SB-10057954-1433

Title: Rear S Cam Tube/ Bracket part update

Applies To: Prostar, CAT, LoneStar, Durastar, WorkStar, TranStar

Figure #1: Cam Tube

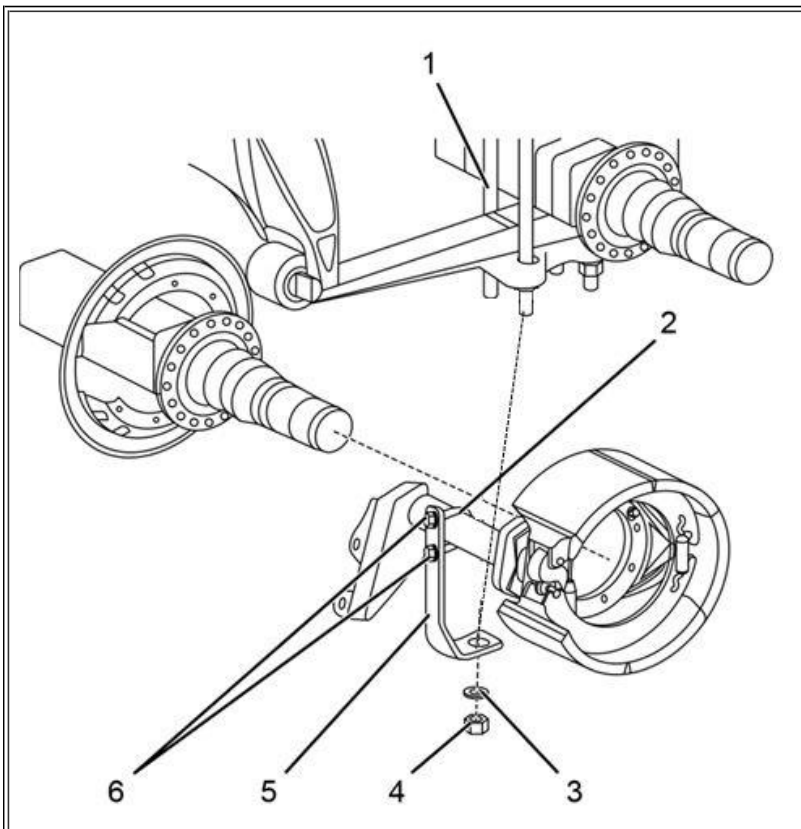
NOTE: On certain wide base axle applications the new SCAM gusseted bracket will come into contact with the old support brackets. It will be necessary to order and relocate new s-cam Support bracket to the out board side of the U-bolt (Bolt closest the wheel).

If replacing passenger side (right side) s-cam bracket you will need new s-cam support bracket part # 3668032C1

If replacing Driver Side (left side) s-cam bracket you will need new s-cam support bracket part # 3668033C1

1. Remove and discard old support bracket

2. Remove Out Board U-Bolt Nut

3. To ensure proper installation of cam tube support bracket, perform the following:

- a. Slide new cam tube support bracket (Figure 1, Item 5) over the out board U-bolt (Figure 1, Item1)
- b. Position exhaust pipe clamp (Figure 2, Item 2) on cam tube support bracket (Figure 2, Item 5) and through cam tube support bracket slots with two washers and nuts

Figure # 2: Support Bracket

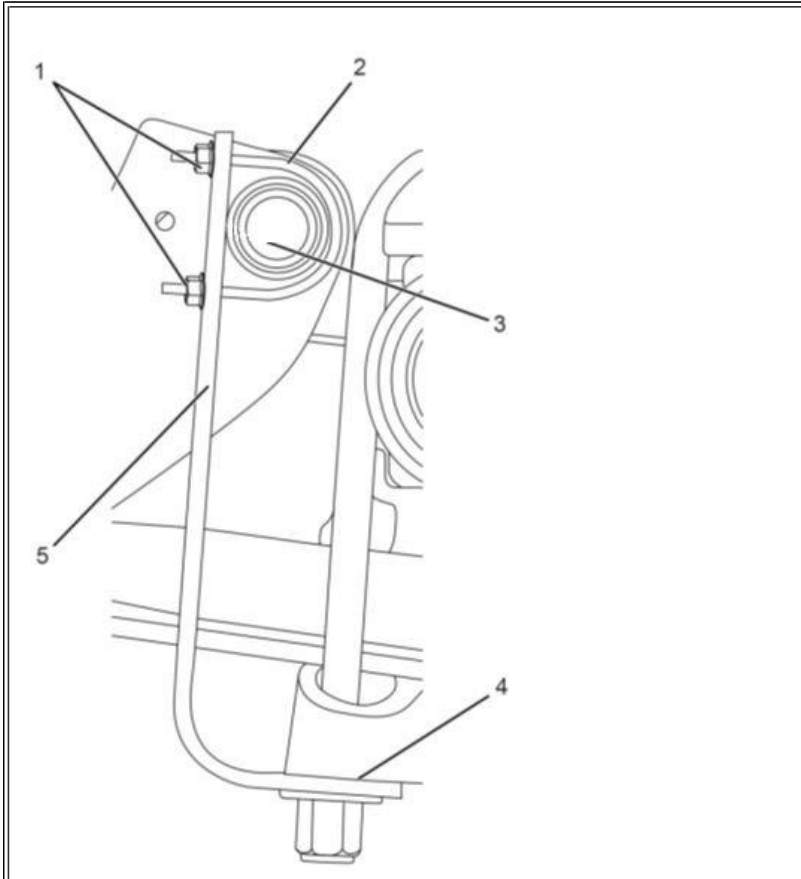
c. Ensure cam tube support bracket (Figure 2, Item 5) is contacting cam tube (Figure 2, Item 3) and is sitting flush against rear U-bolt spring plate (Figure 2, Item 4).

d. Using torque wrench, tighten two nuts (Figure 2, Item 1) to 60 - 72 lb-in (6.8 - 8.1 N•m).
